## **2.6 Reactor Auxiliary Systems**

The information in this section of the reference ABWR DCD, including all subsections, tables, and figures is incorporated by reference with the following departure to Figure 2.6.2.

Figure 2.6.2 Fuel Pool Cooling and Cleanup System

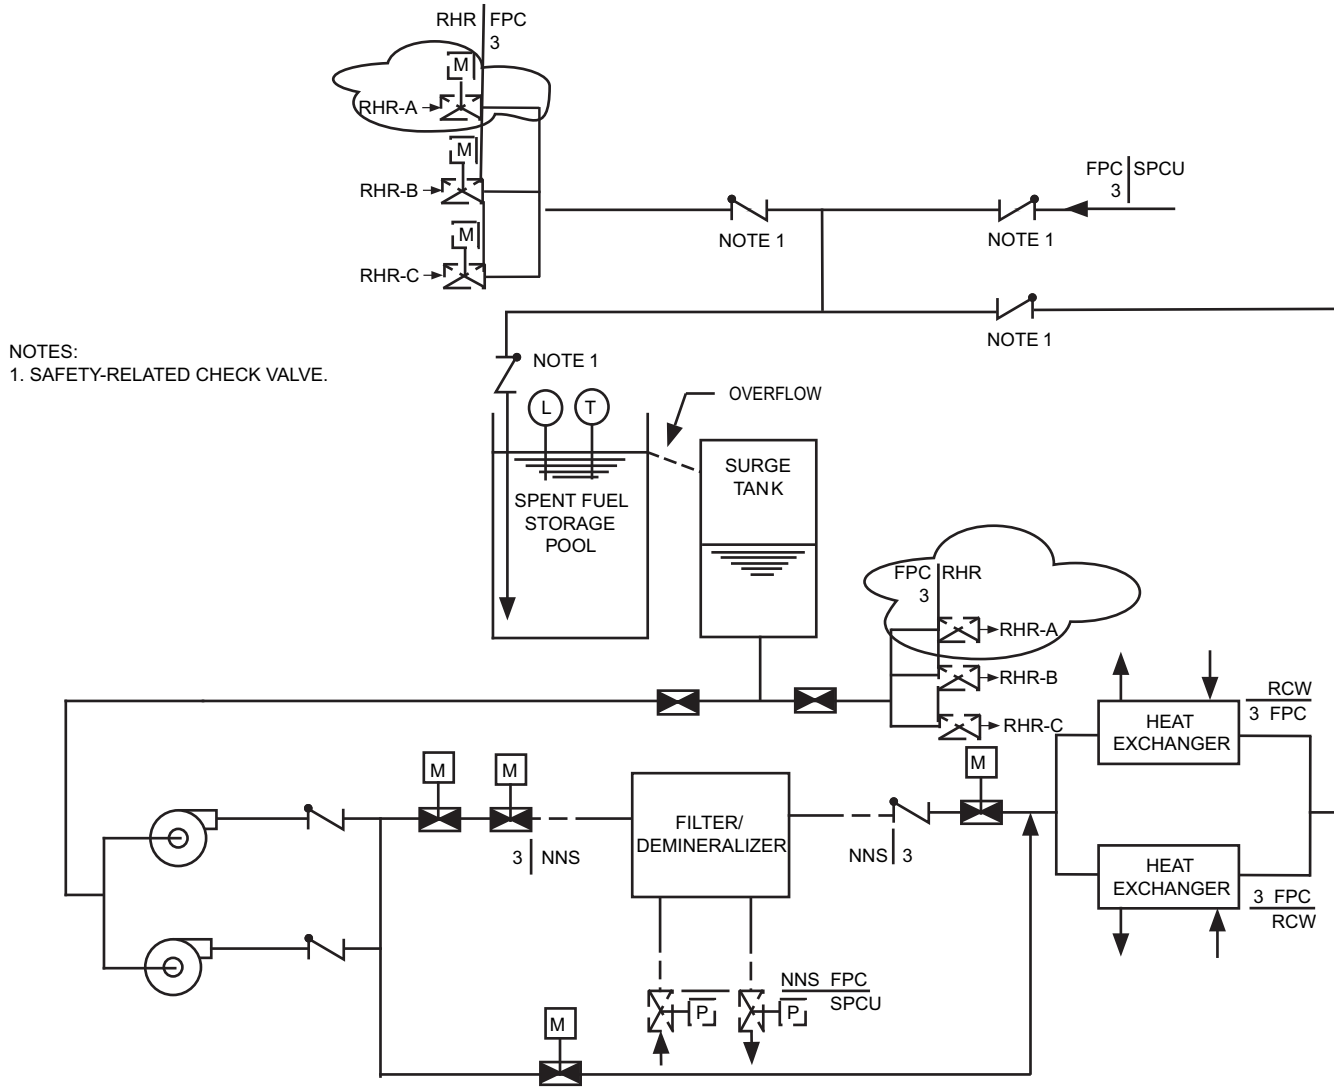
STD ~~T1-DEP~~ DEP T1 2.4-1
